your Driver

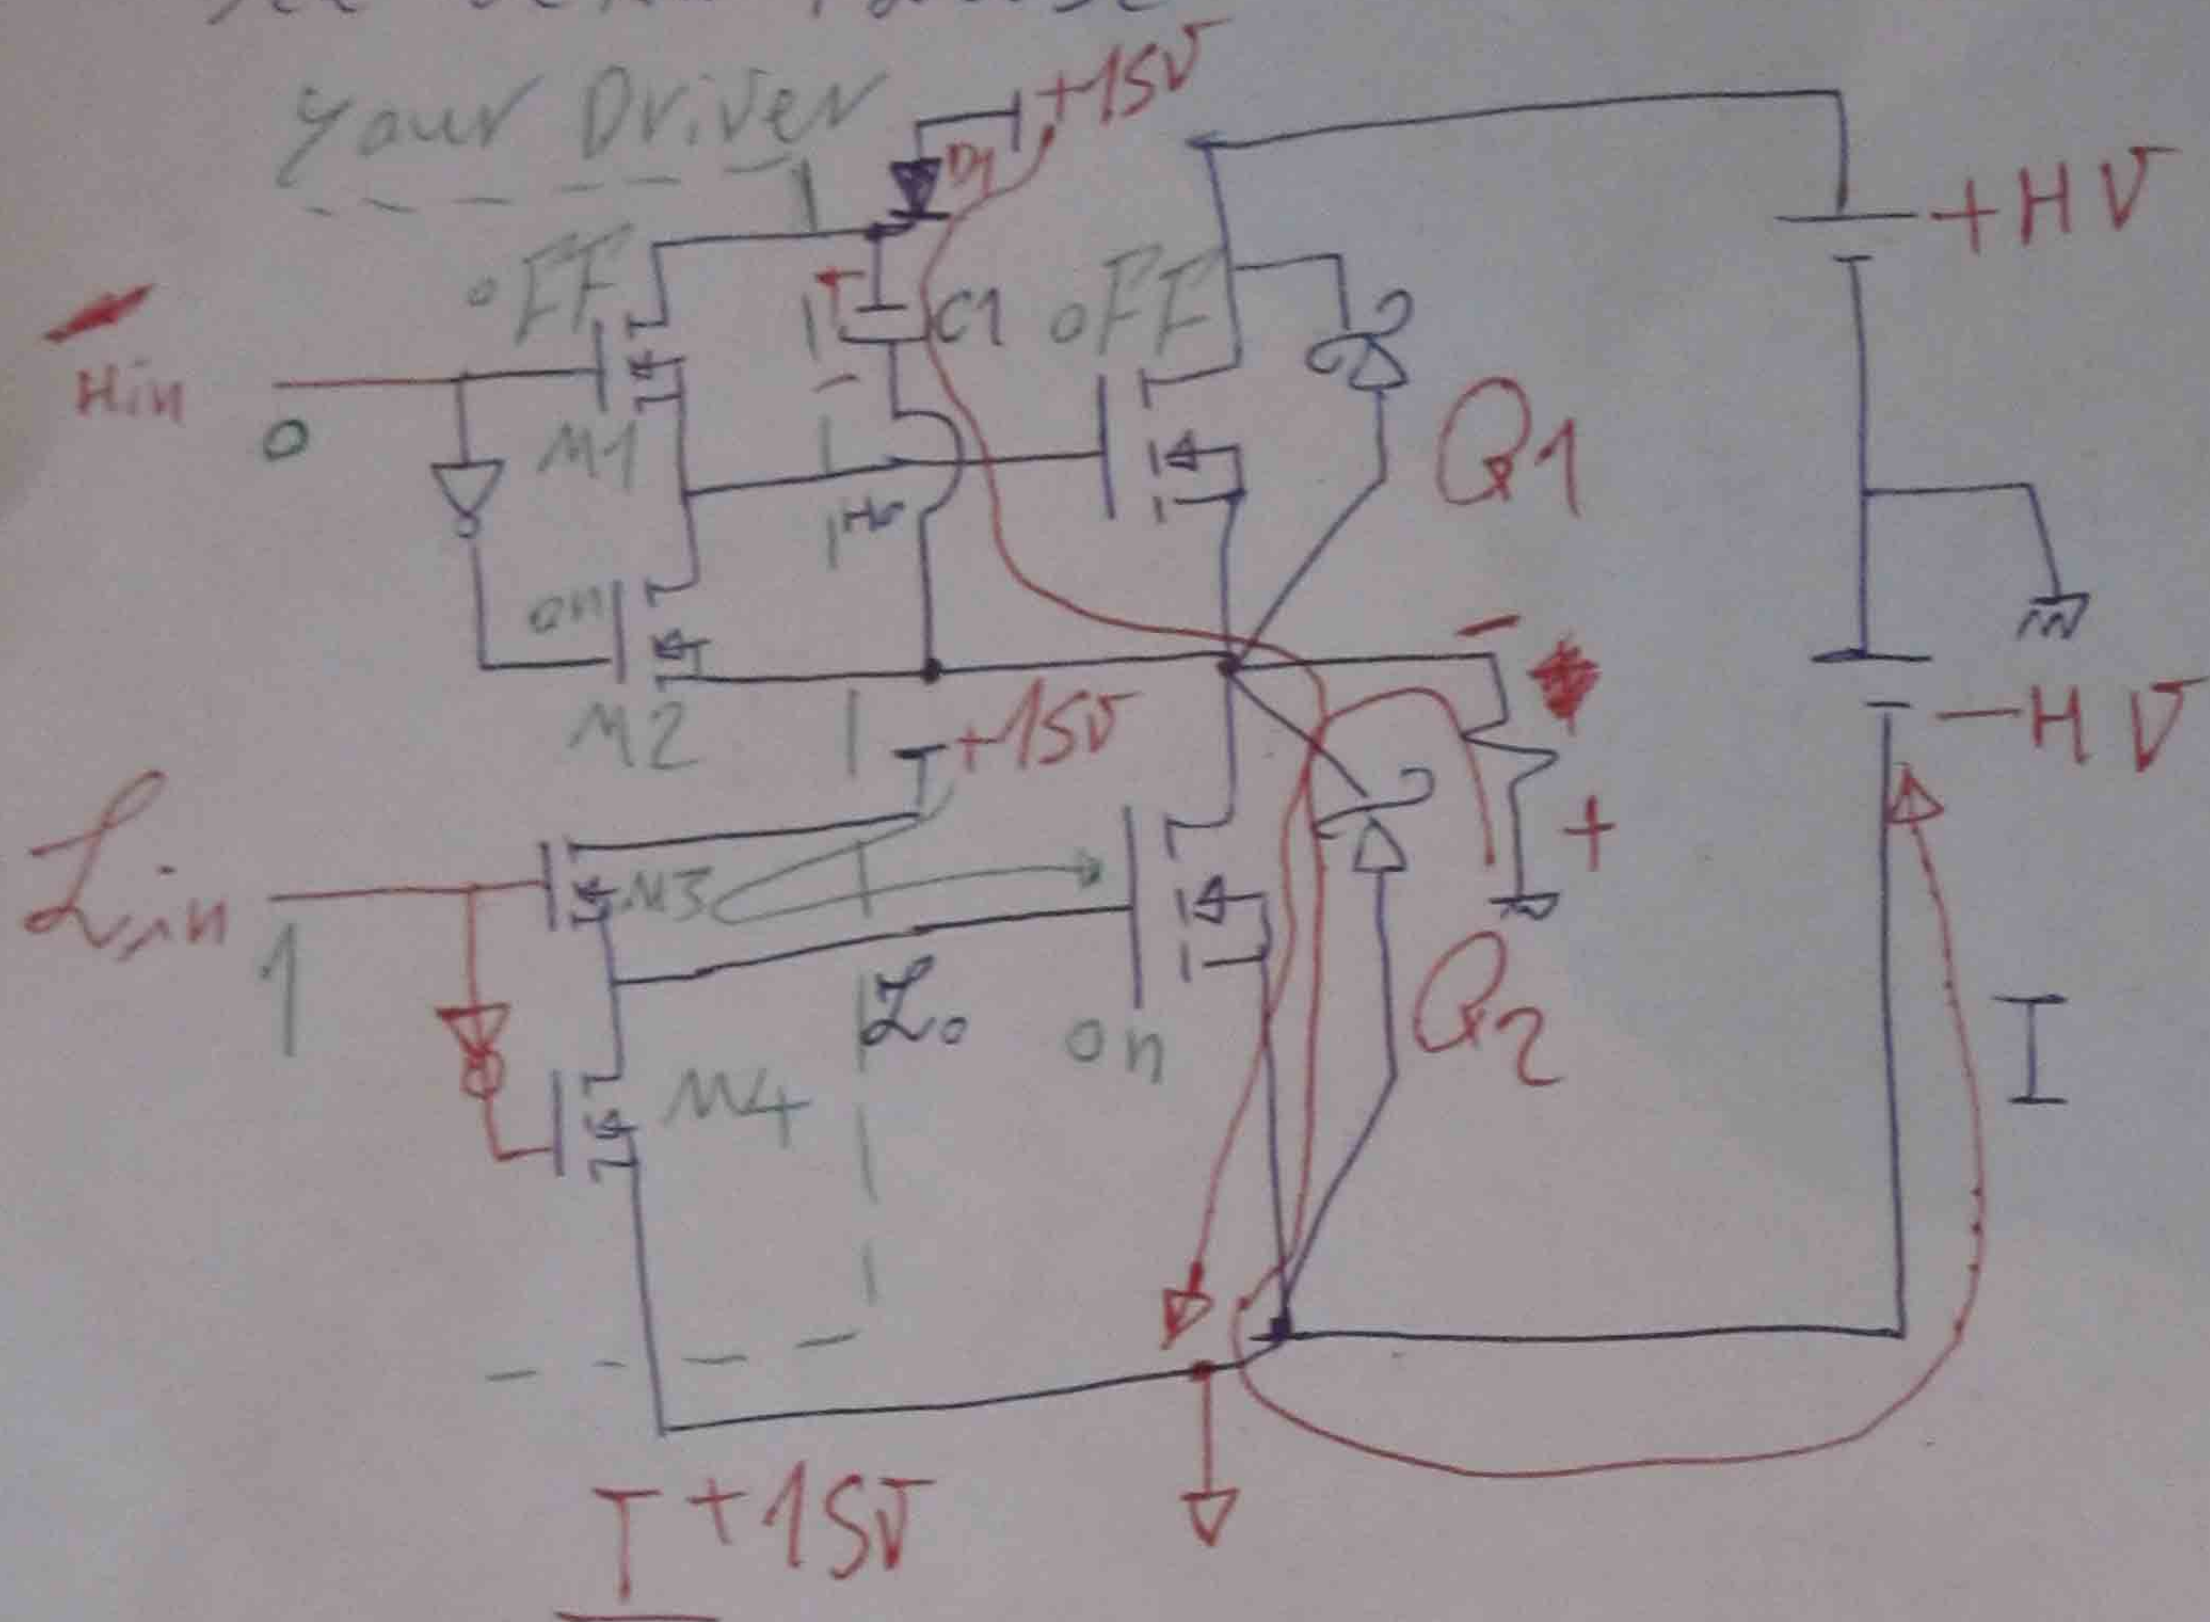
When L_{in} is 1 and H_{in} is 0, $M1$ is OFF and $M2$ is ON (thus G_S of $Q1$ is short circuit) and $M3$ is ON and $M4$ is OFF thus $C1$ will create a loop from $+15$ up to the ground of $15V$ supply. (we connected its ground to the minus supply) so when H_{in} is 1 and L_{in} is 0. what will happen? see Page 2, Please
